SUBJECT: SAFETY RECALL NOTIFICATION

SAFETY RECALL

Sr05-14

DATE : November 2005	SECTION : 06
SUBJECT : NEW MULTIPLEX SOFTWARE PROGRAM AND INSTALLATION OF NEW WIPER HARNESS

FIGURE 4: CABLE 066734

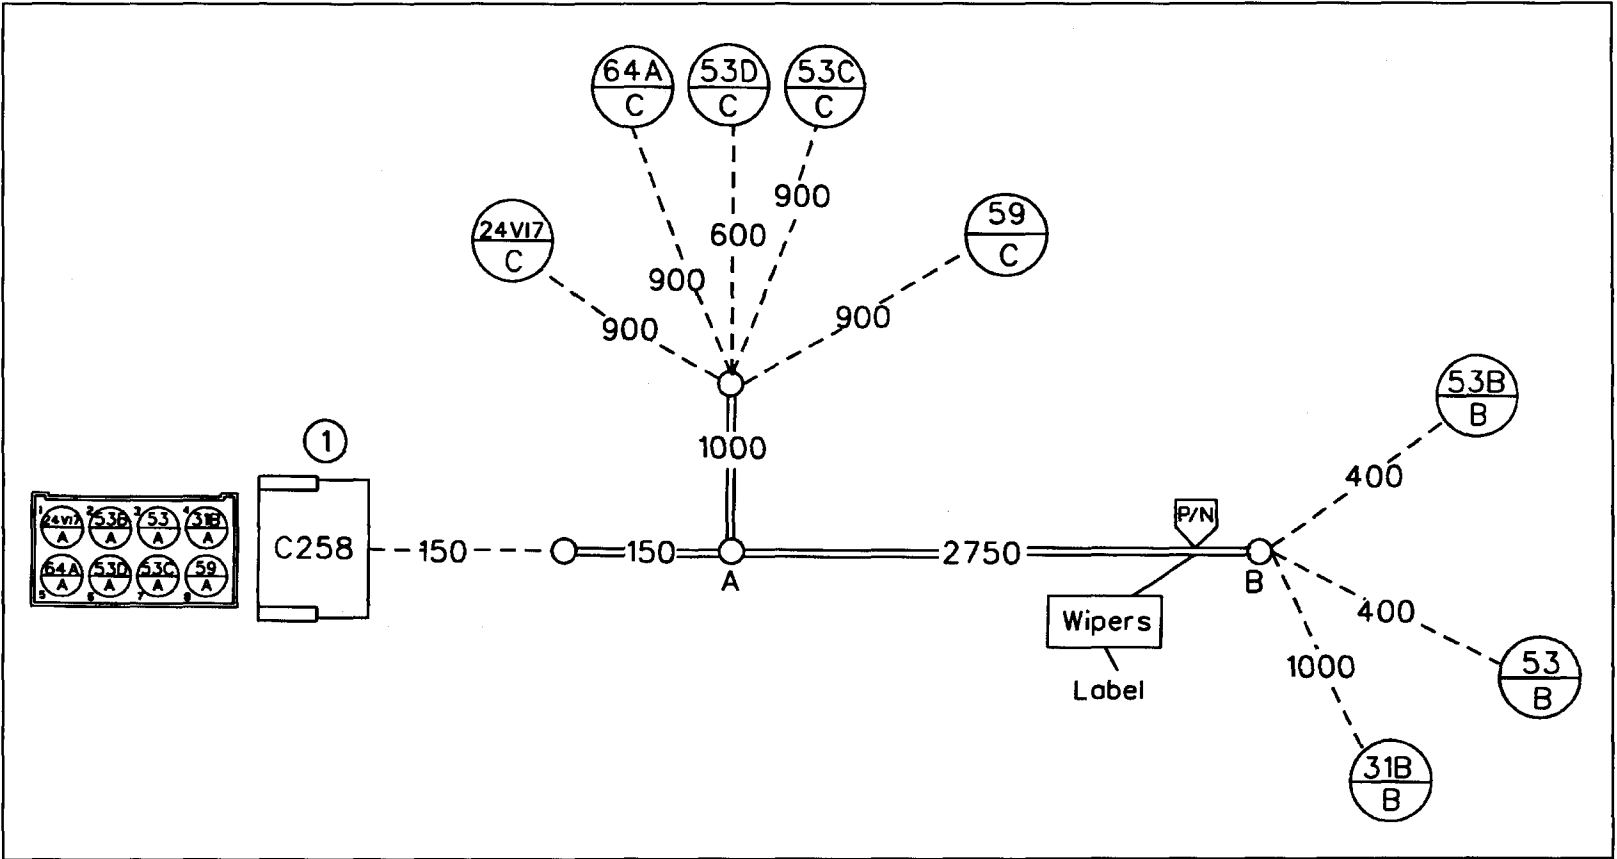
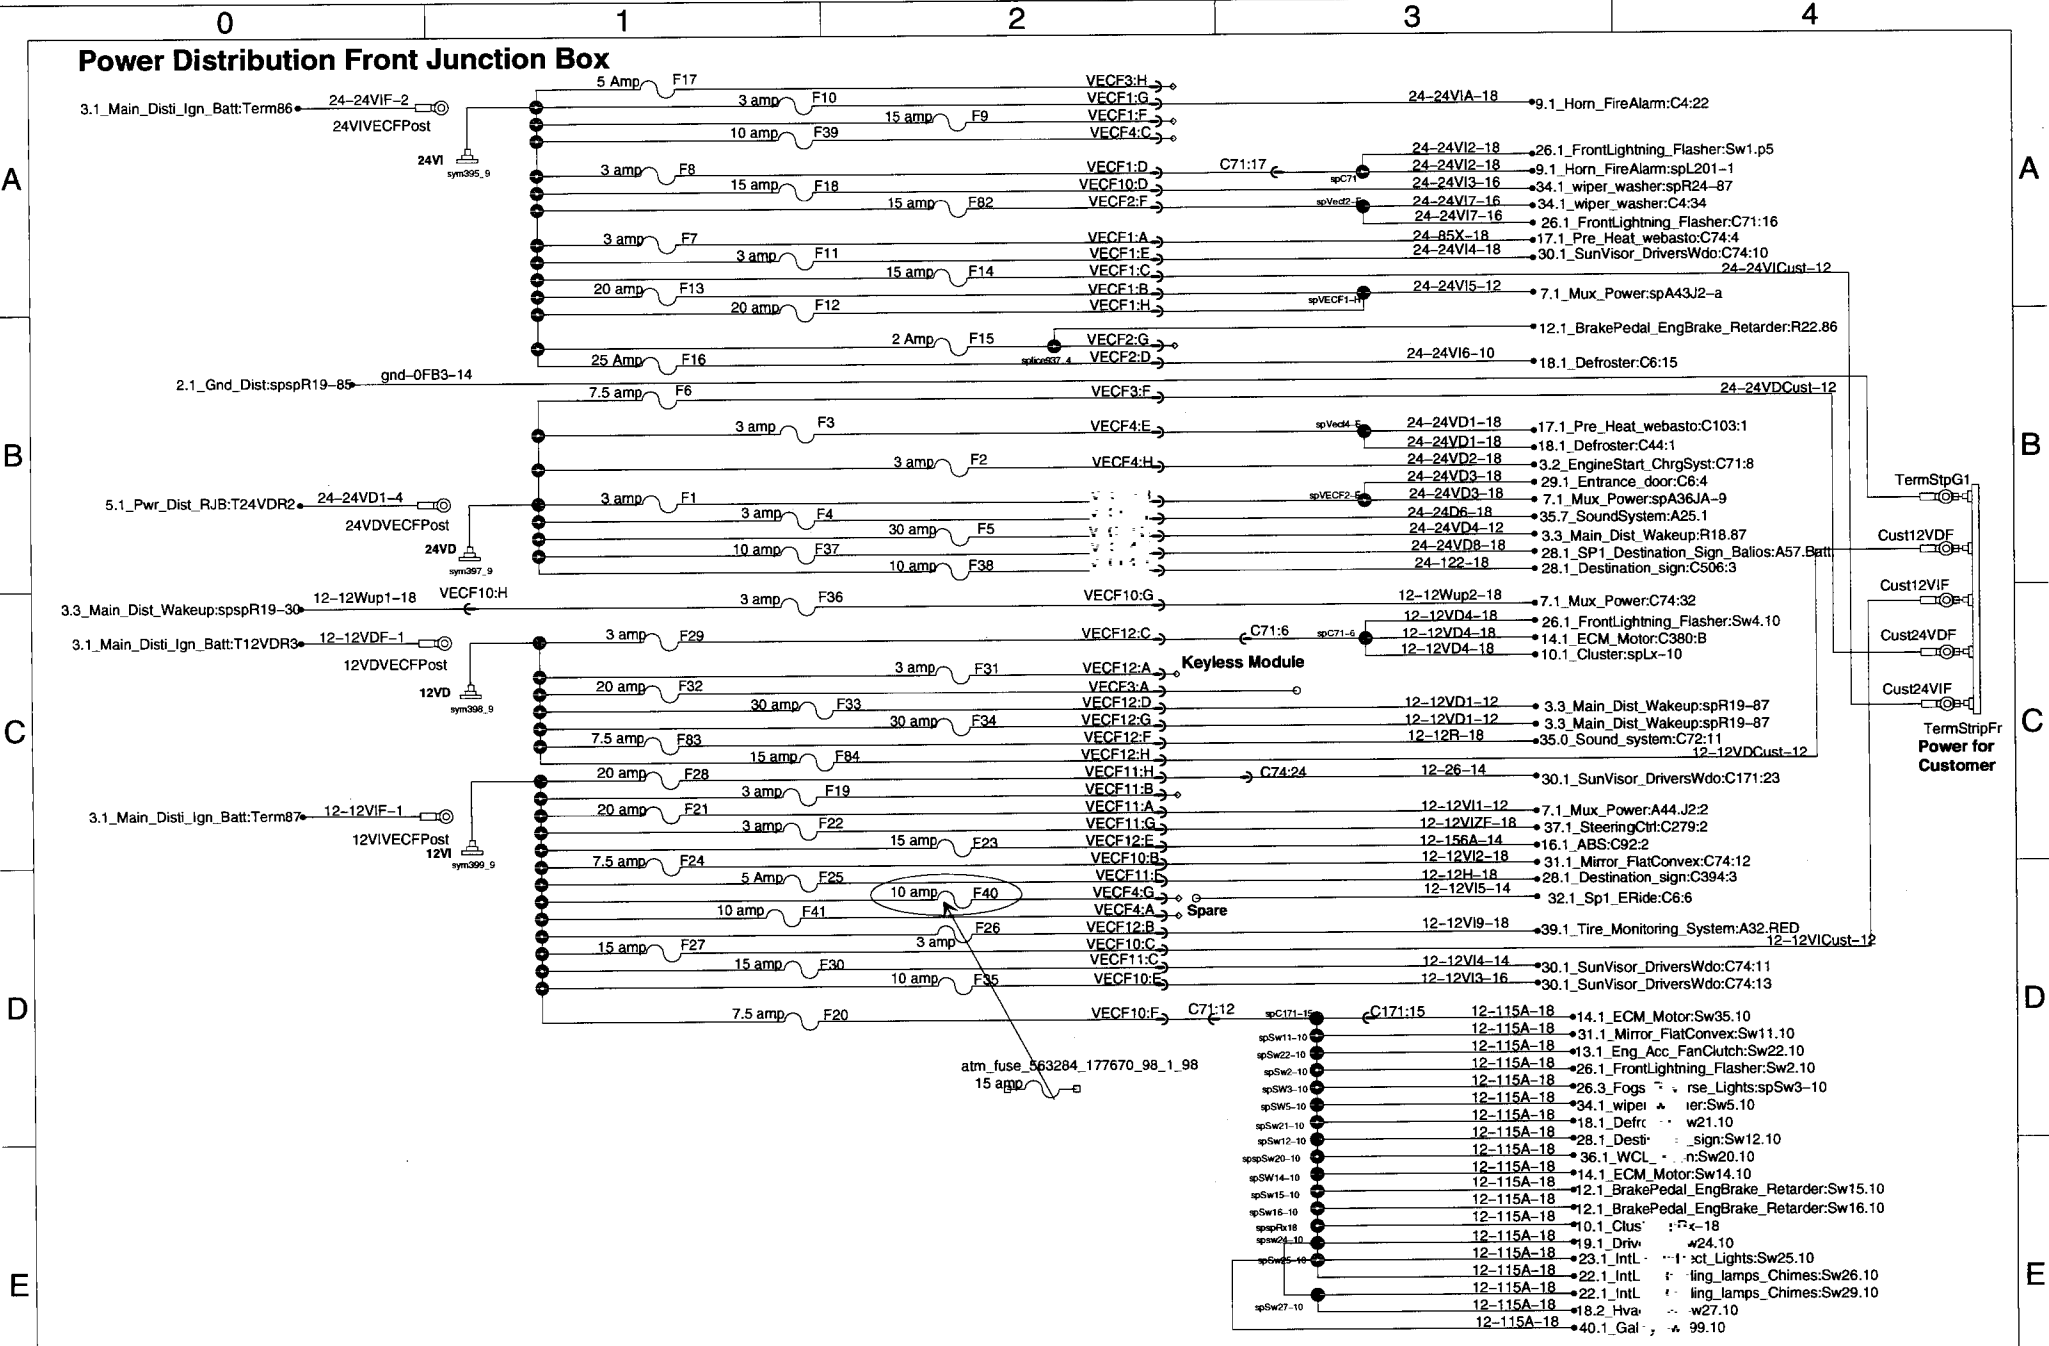
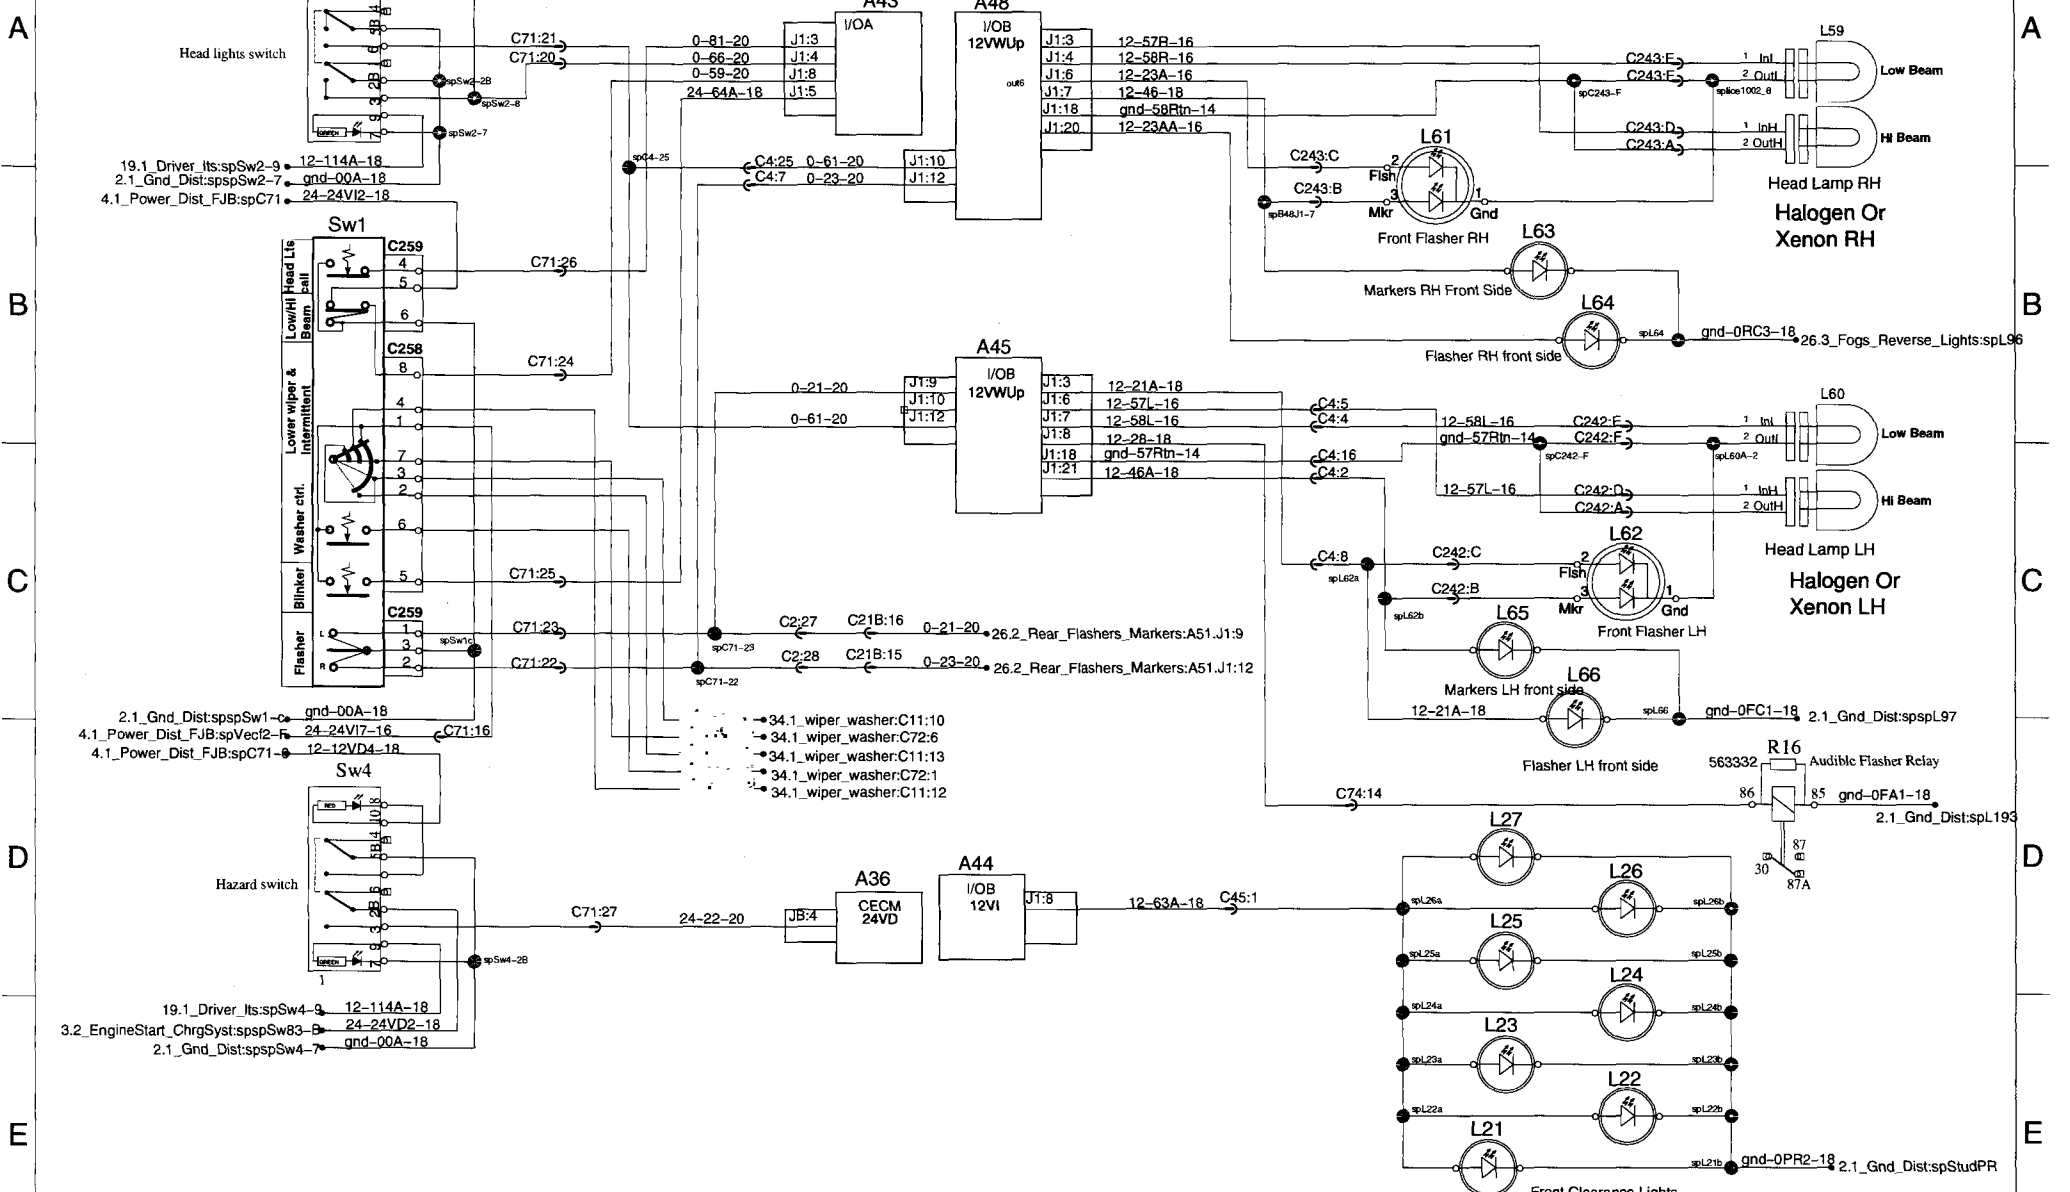
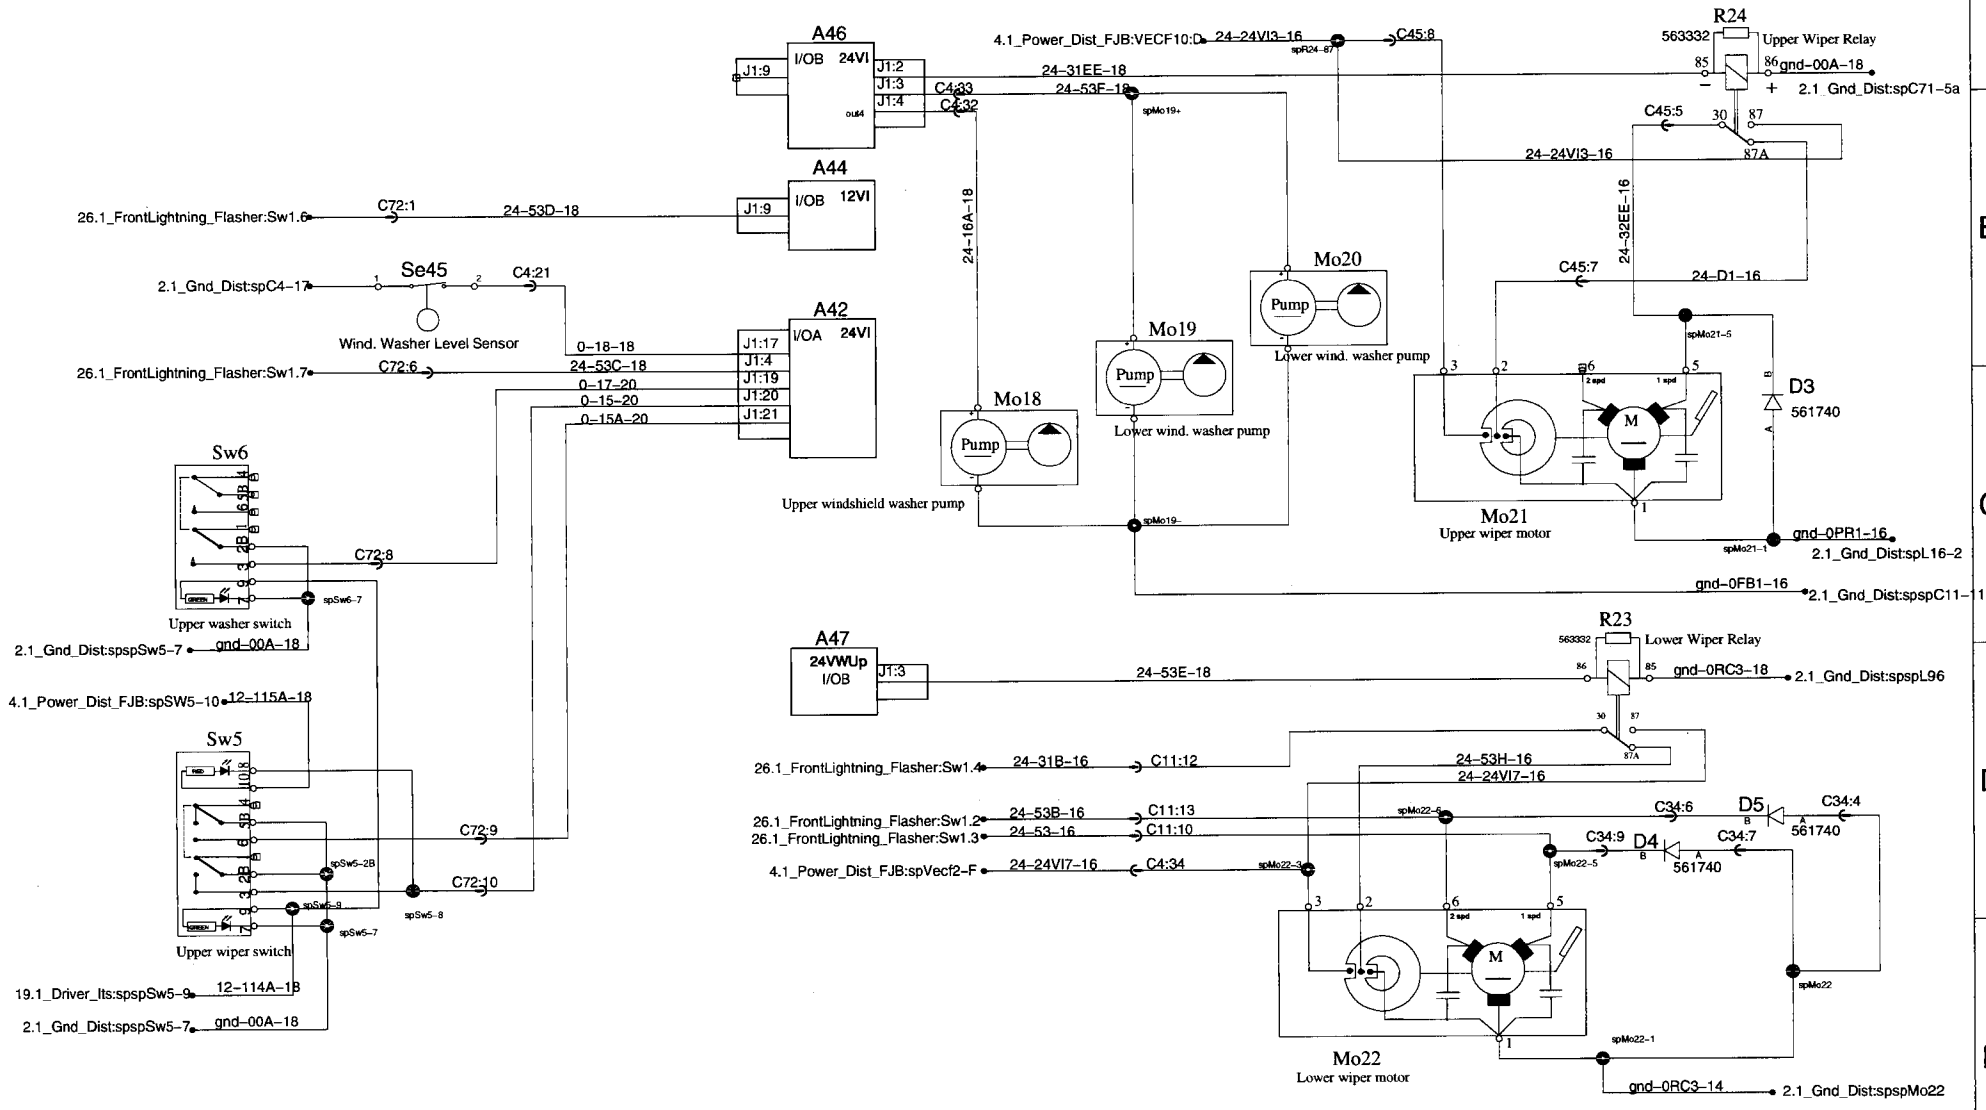
Part No.	Description	Qty
066734	Harness, Wiper retrofit	1
562934	Butt Splice	2
561918	Tubing, Heat Shrink	1
